Addendum No. 3

ITB No. 25-35

HONEY CREEK & SCOTT CREEK PUMP STATIONS & FORCE MAINS

March 11, 2026

DRAWING No. C-38

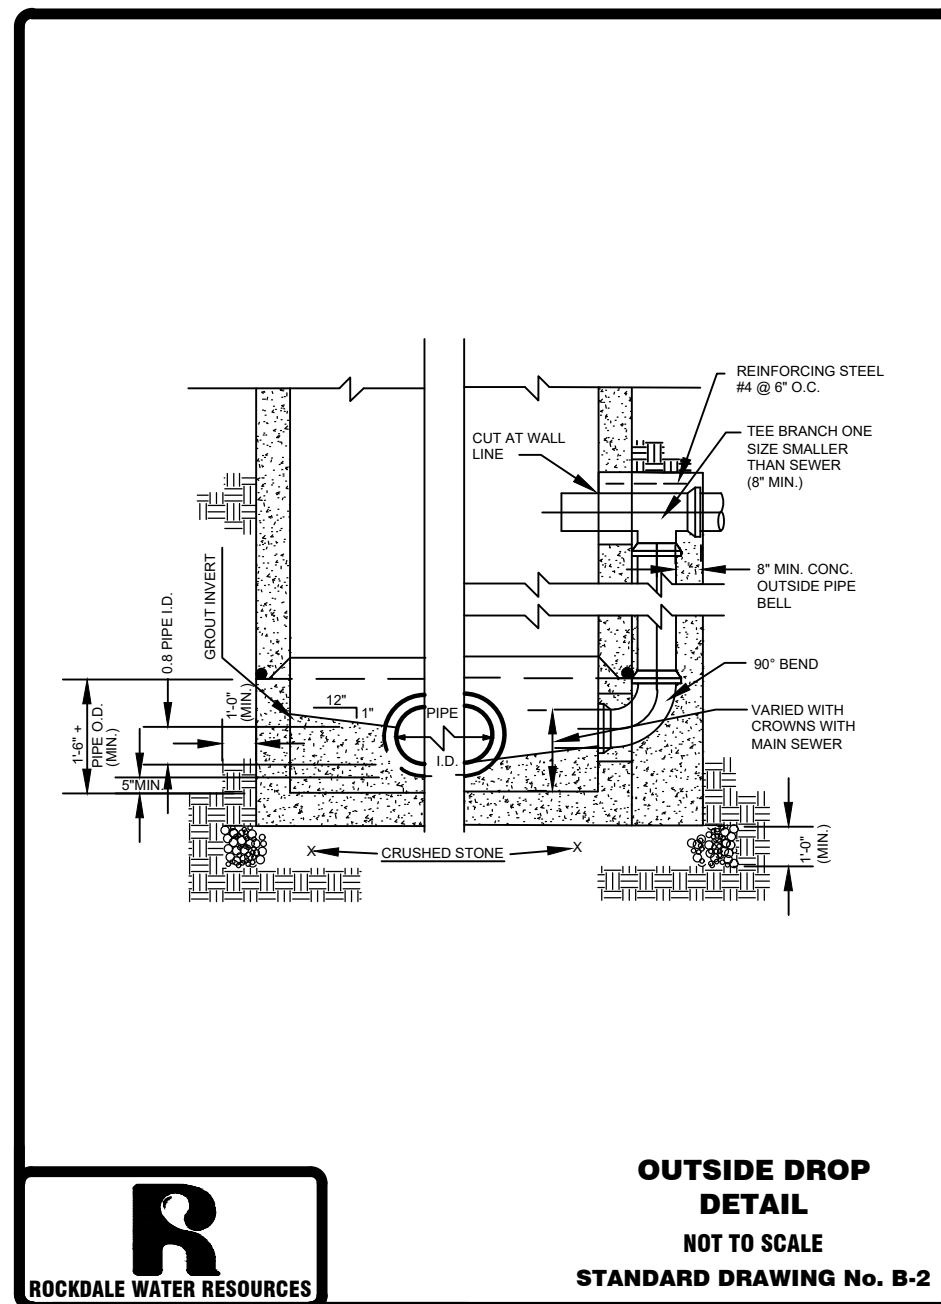
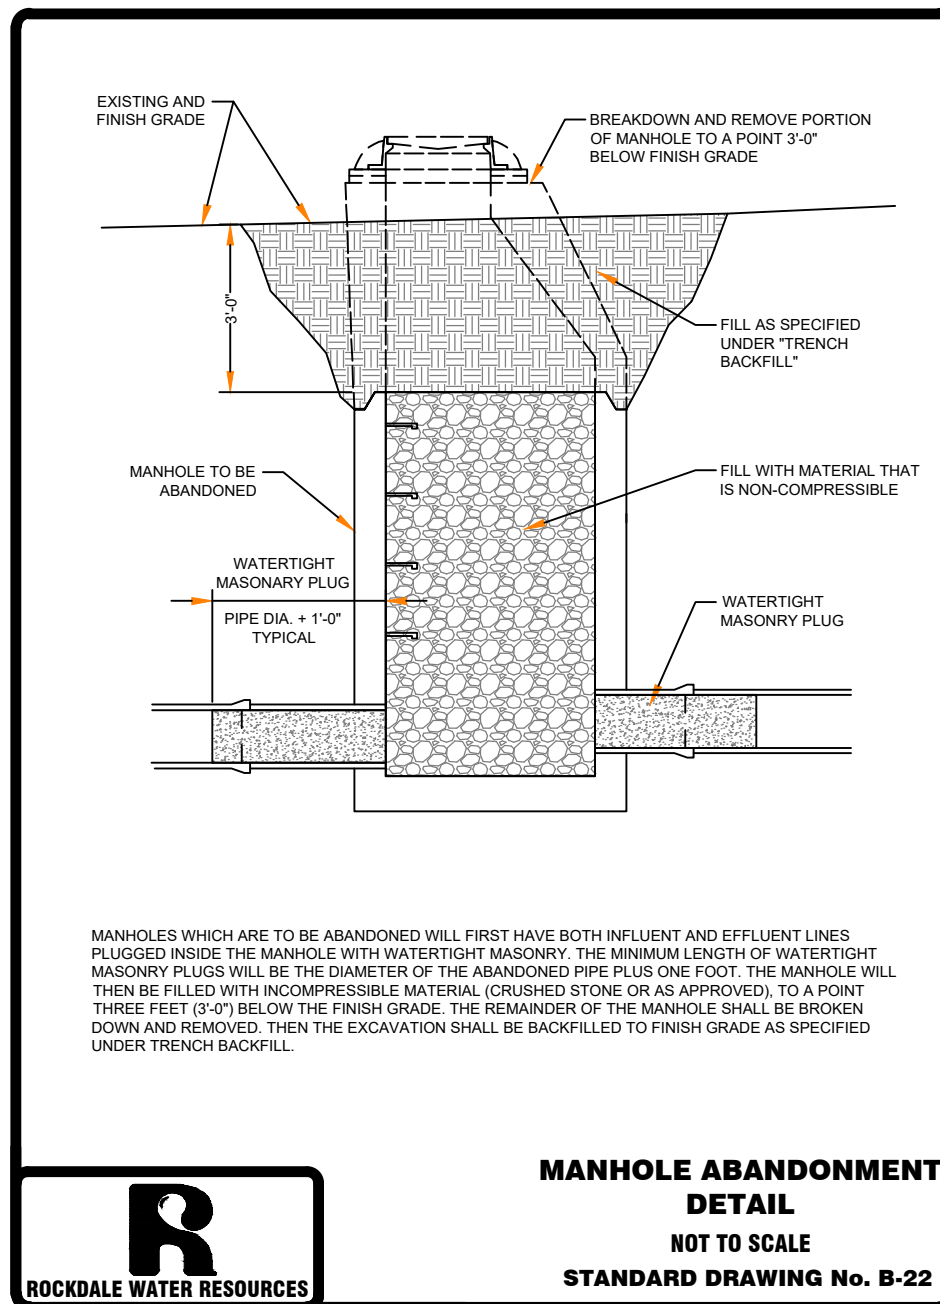
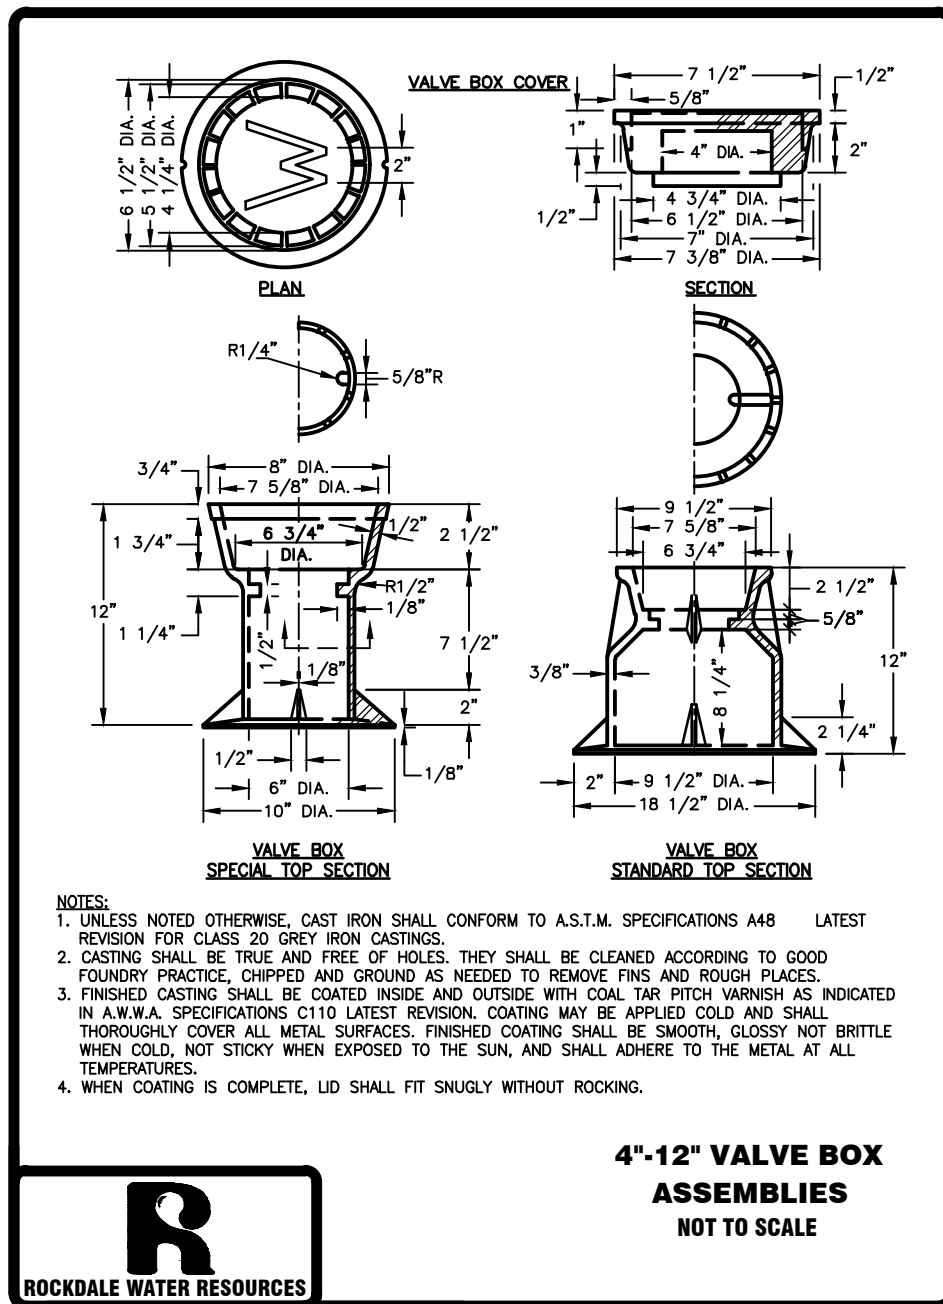
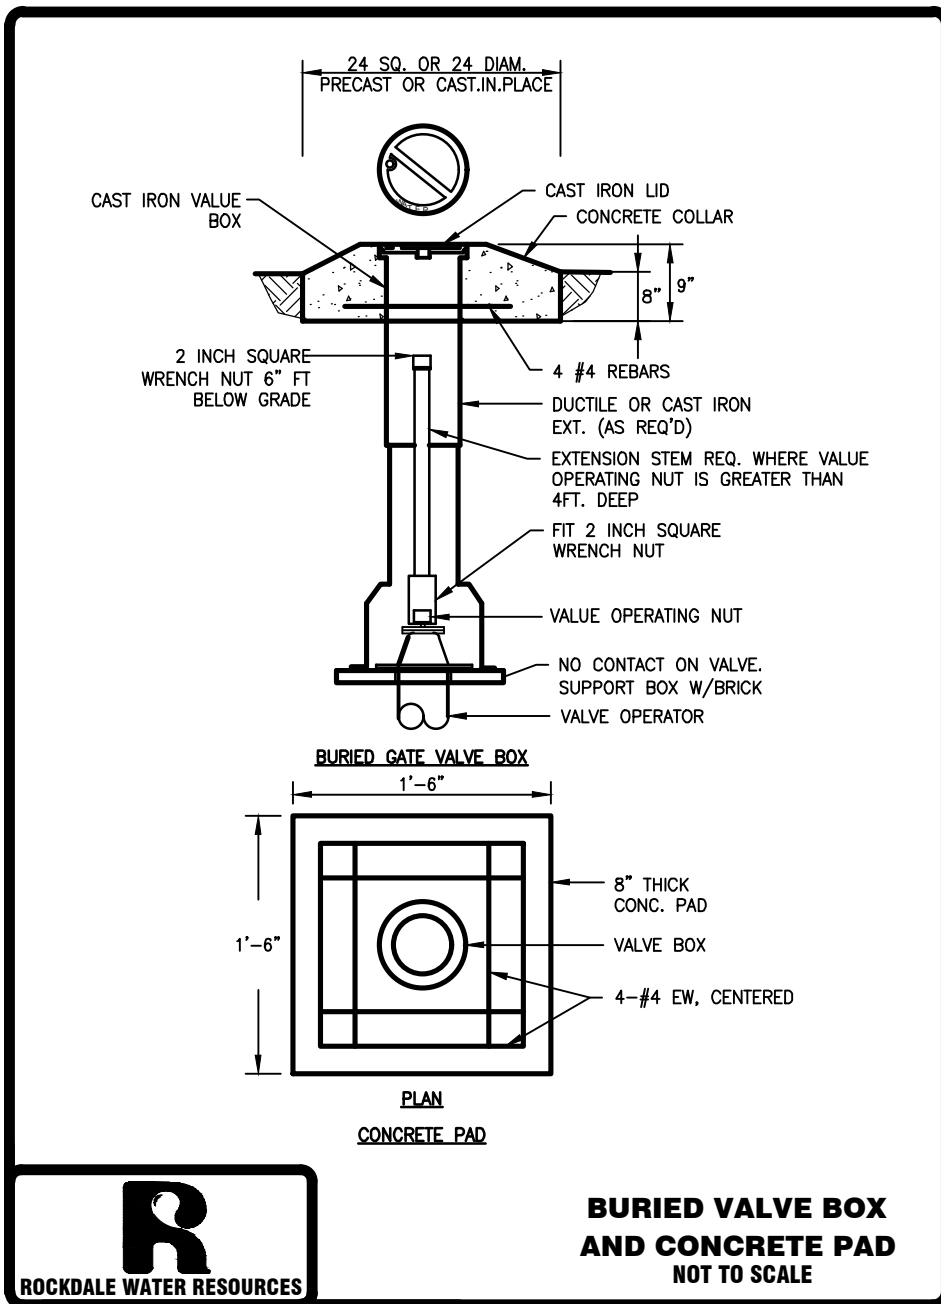
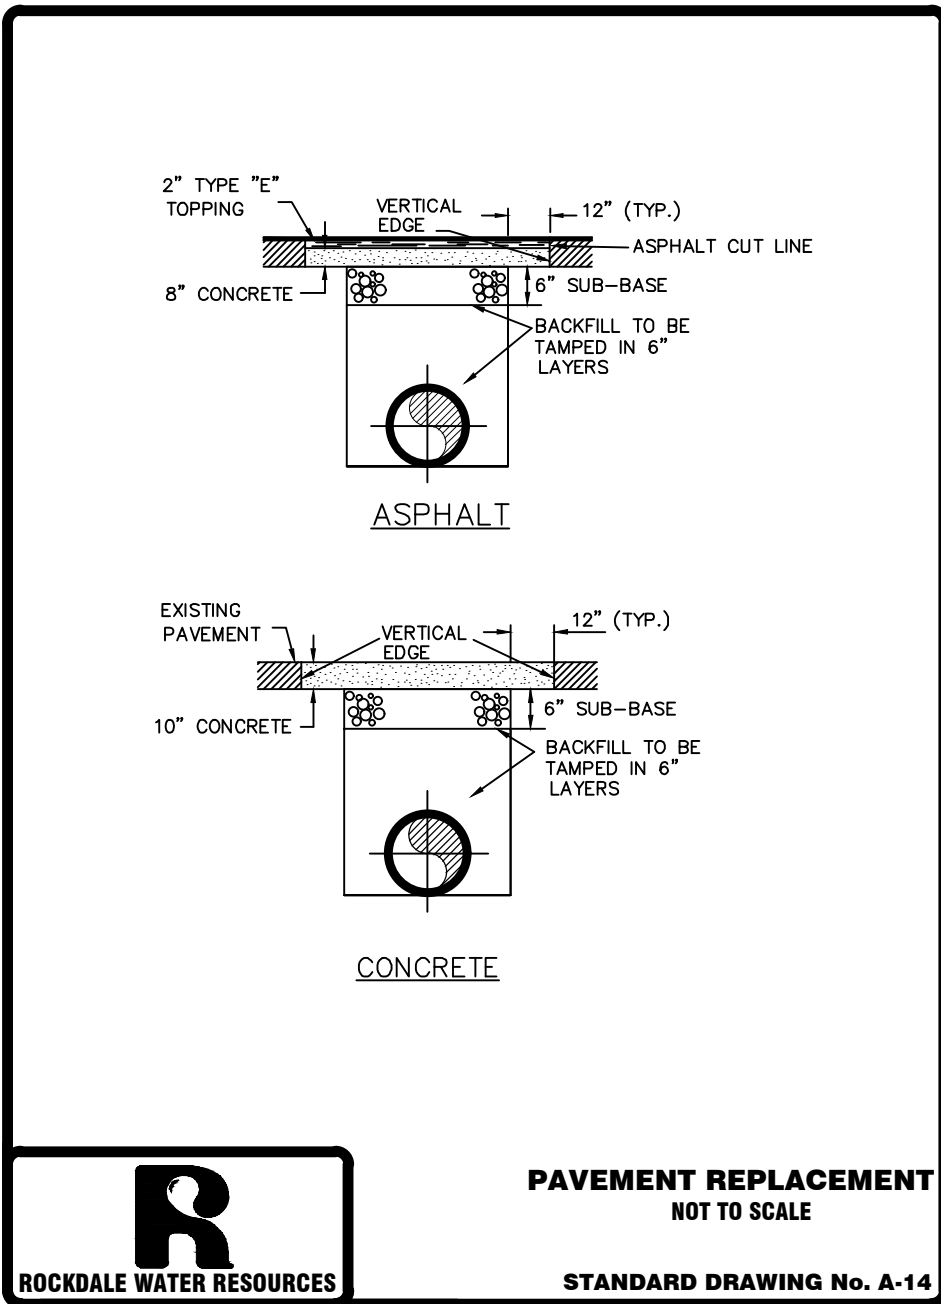
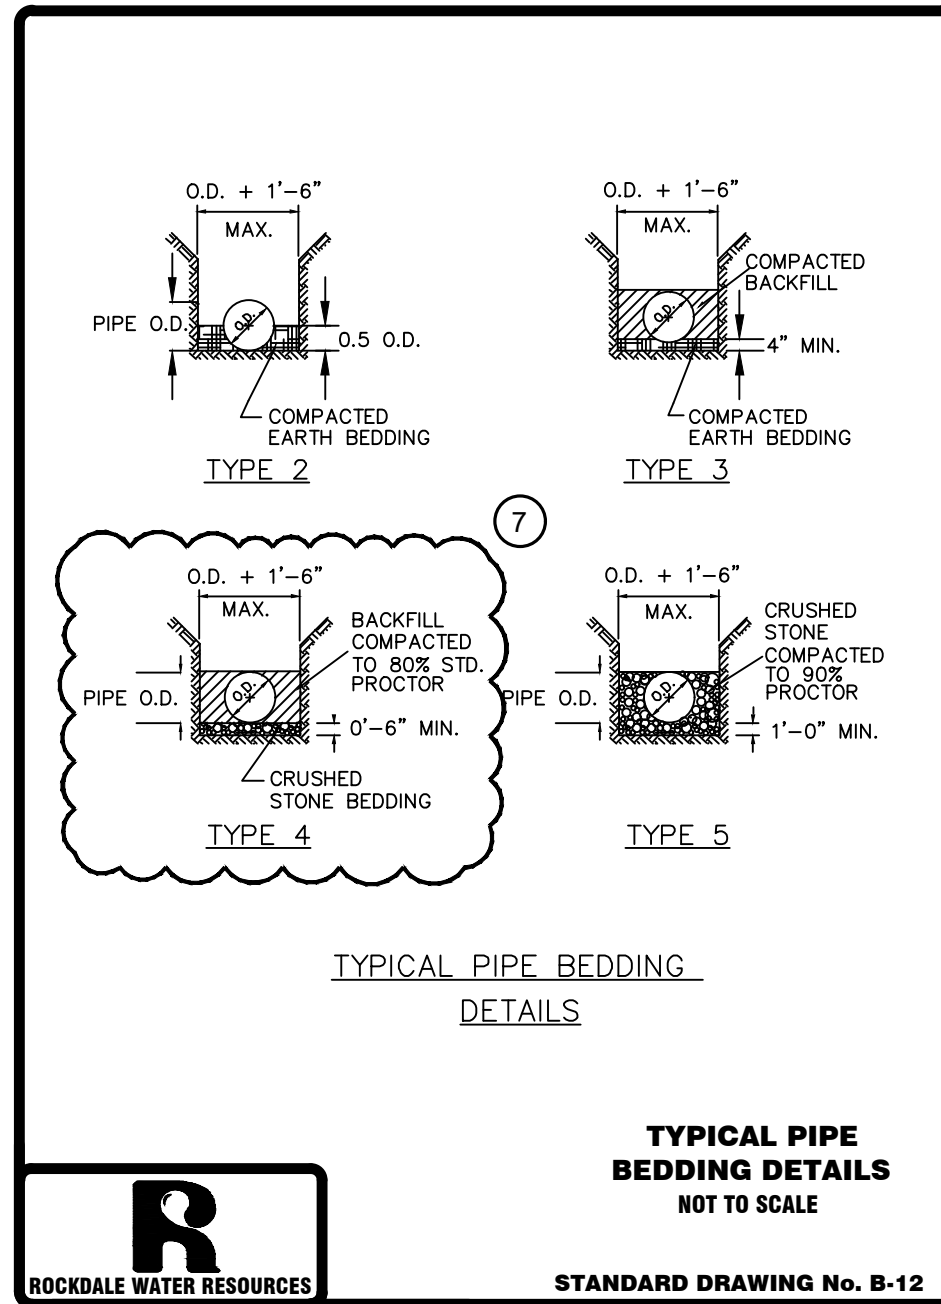
A. Question: What is the pipe bedding detail that should be used?

Answer: Please use the Type 4 bedding shown on bedding detail B-12 on revised sheet C-38 which is included with this addendum.
